ECE/TRANS/WP.29/2006/110  
13 July 2006

World Forum for Harmonization of Vehicle Regulations (WP.29)

PROPOSAL FOR 03 SERIES OF AMENDMENTS TO REGULATION No. 11  
(Door latches and door retention components)

Submitted by the Working of Passive Safety (GRSP)

Figure 3-1 – Door Latch - Tensile Testing Fixture for Load Test One

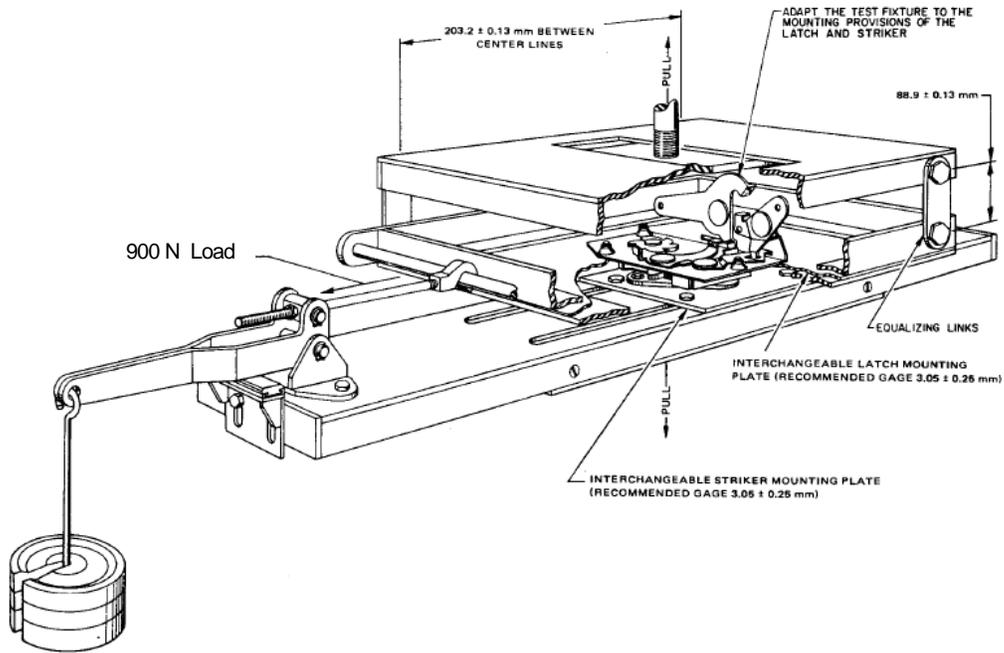
Annex 3, including its appendix, amend to read:

2.1.1. Equipment: Tensile testing fixture (see Figure 3-1).

2.1.2.1.1. Adapt the test fixture to the mounting provisions of the latch and striker. Align the direction of engagement parallel to the linkage of the fixture. Mount the latch and striker in the fully latched position to the test fixture.

2.1.2.1.2. Locate weights to apply a 900 N load tending to separate the latch and striker in the direction of the door opening.

2.1.2.1.3. Apply the test load, in the direction specified in paragraph 6.1.1. of this Regulation and Figure 3-4, at a rate not to exceed 5 mm/min until the required load has been achieved. Record the maximum load achieved.

Figure 3-2 – Door Latch – Tensile Testing Fixture for Load Test Two

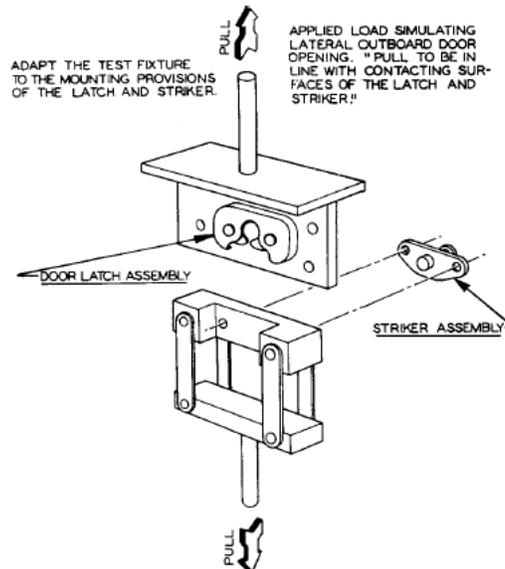
- 2.2. Load Test Two
  - 2.2.1. Equipment: Tensile testing fixture (see Figure 3-2).
  - 2.2.2. Procedures
    - 2.2.2.1. Fully Latched Position
      - 2.2.2.1.1. Adapt the test fixture to the mounting provisions of the latch and striker. Mount the latch and striker in the fully latched position to the test fixture.

- 2.2.2.1.2. Apply the test load, in the direction specified in paragraph 6.1.2. of this Regulation and Figure 3-4, at a rate not to exceed 5 mm/min until the required load has been achieved. Record the maximum load achieved.

Figure 3-3 - Door Latch – Tensile Testing Fixture for Load Test Three (Back Doors Only)

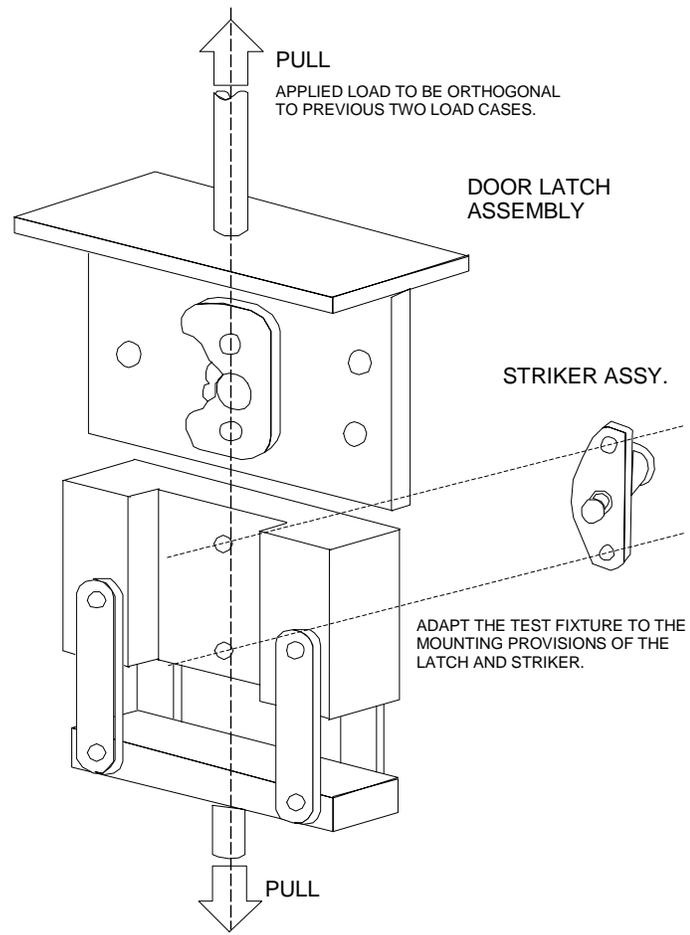
- 2.3. Load Test Three (Back Doors Only)
  - 2.3.1. Equipment: Tensile testing fixture (see Figure 3-3).
  - 2.3.2. Procedure
    - 2.3.2.1. Adapt the test fixture to the mounting provisions of the latch and striker. Mount the latch and striker in the fully latched position to the test fixture.

- 2.3.2.2. Apply the test load, in the direction specified in paragraph 6.1.3. of this Regulation and Figure 3-4, at a rate not to exceed 5 mm/min until the required load has been

Figure 4-2 – Acceleration Pulse

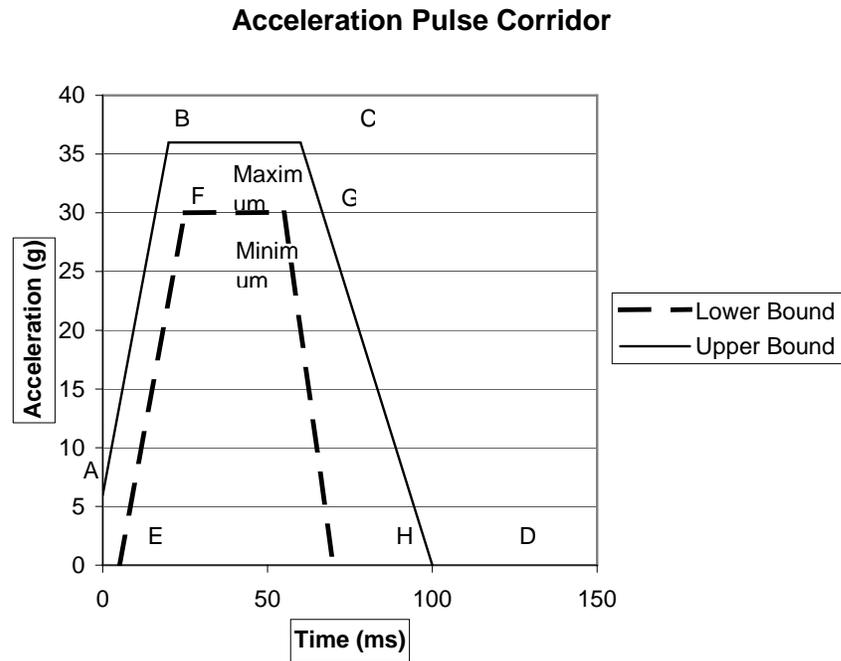
- 2.4. Test Operation for Options 2 and 3
  - 2.4.1. A minimum acceleration level of 30 g shall be maintained over a period of at least 30 ms, while keeping the acceleration within the pulse corridor as defined in Table 4-1 and graphically shown in Figure 4-2.

Figure 4-3 - Vehicle Coordinate Reference System for Inertial Testing

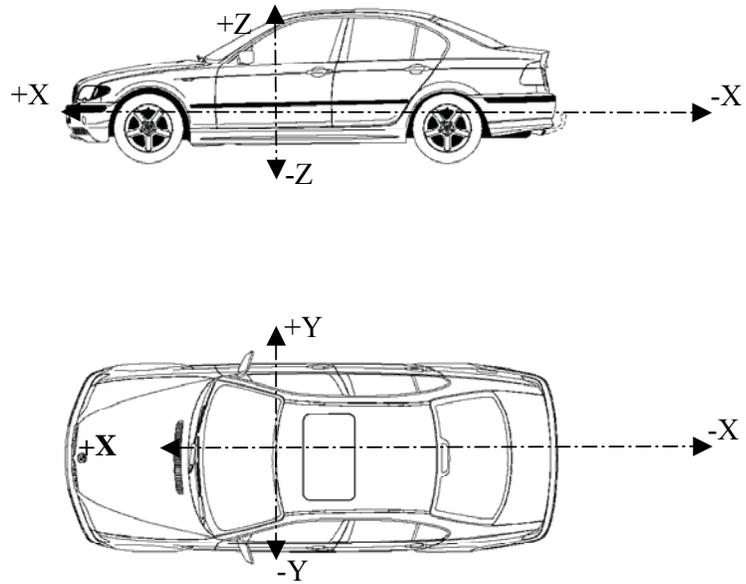
- 2.2.3. Test Directions (see Figure 4-3)
  - 2.2.3.1. Longitudinal Setup 1. Orient the vehicle or body in white so that its longitudinal axis is aligned with the axis of the acceleration device, simulating a frontal impact.

- 2.3.3. Test Directions (see Figure 4-3)
  - 2.3.3.1. Longitudinal Setup 1. Orient the door subsystem(s) on the acceleration device in the direction of a frontal impact.

Figure 5-1 – Static test fixtures

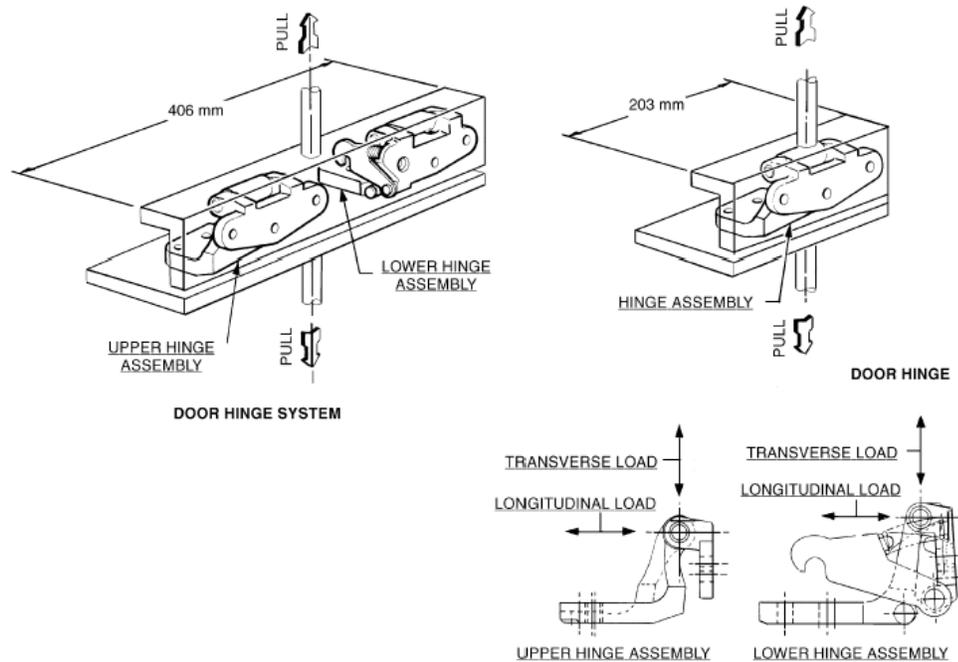
2.1.1.1.2. A typical static test fixture is illustrated in Figure 5-1.

Figure 5-2 – Static load test directions for back doors

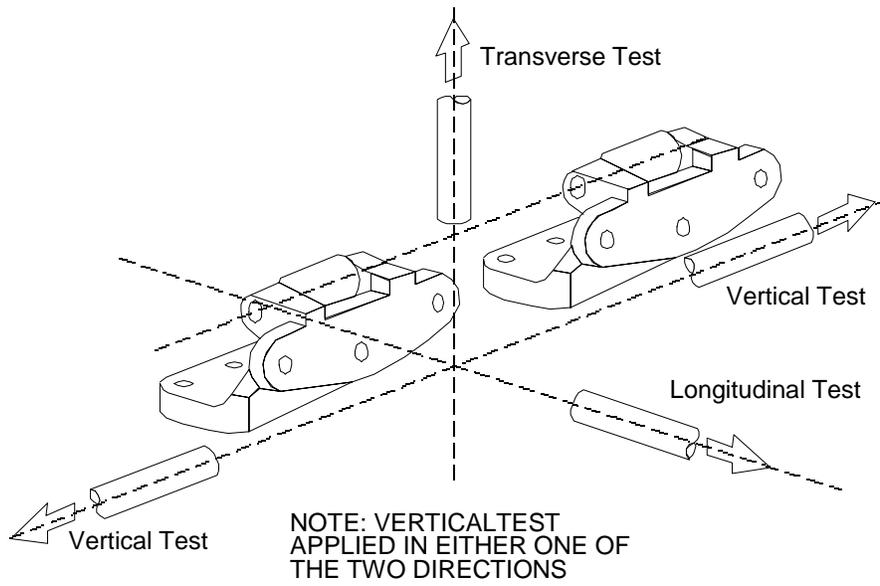
2.1.1.2.1. Attach the hinge system to the mounting provision of the test fixture. Hinge attitude must simulate vehicle position (door fully closed) relative to the hinge centreline. For test purposes, the distance between the extreme ends of one hinge in the system to the extreme end of another hinge in the system is to be set at  $406 \pm 4$  mm. The load is to be applied equidistant between the linear centre of the engaged portions of the hinge pin and through the centreline of the hinge pin in the longitudinal vehicle direction. (see Figure 5-2).

2.1.3.2.1. Attach the hinge system to the mounting provisions of the test fixture. Hinge attitude must simulate vehicle position (door fully closed) relative to the hinge centreline. For test purposes, the distance between the extreme ends of one hinge in the system to the extreme opposite end of another hinge in the system is to be set at  $406 \pm 4$  mm. The load is to be applied through the centreline of the hinge pin in a direction orthogonal to the longitudinal and transverse loads. (see Figure 5-2).

**Figure 6-1 – Sliding Side Door Full Vehicle Test Procedure**  
(Note: Sliding door is shown separated from the vehicle)"

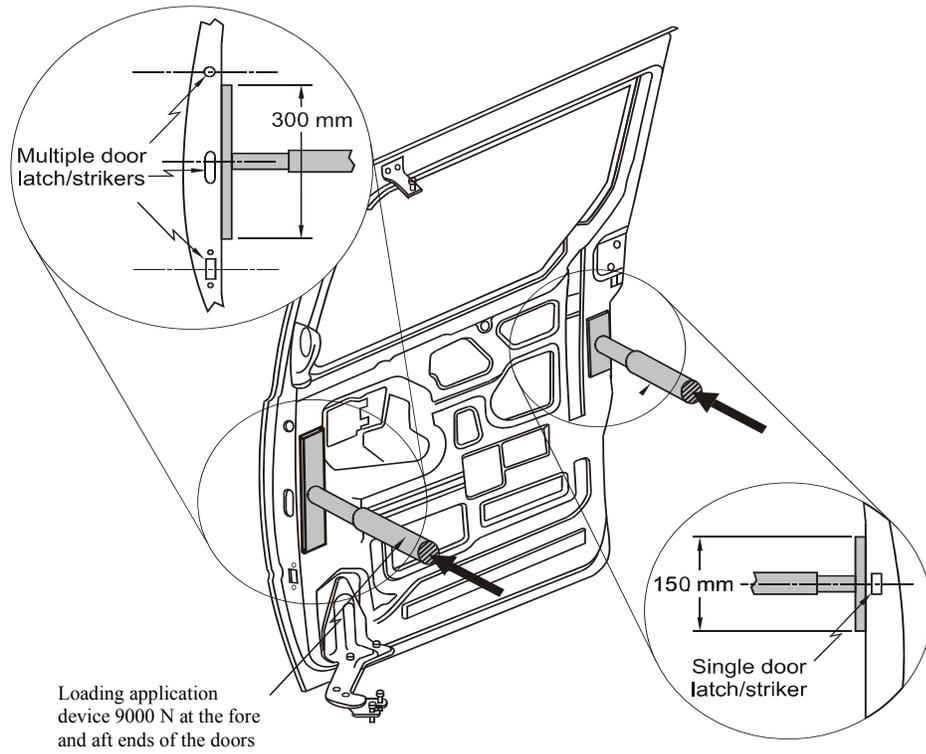
2.2. The test is conducted using two force application devices capable of applying the outward transverse forces specified in paragraph 6.2.4. of this Regulation. The test setup is shown in Figure 6-1. The force application system shall include the following:
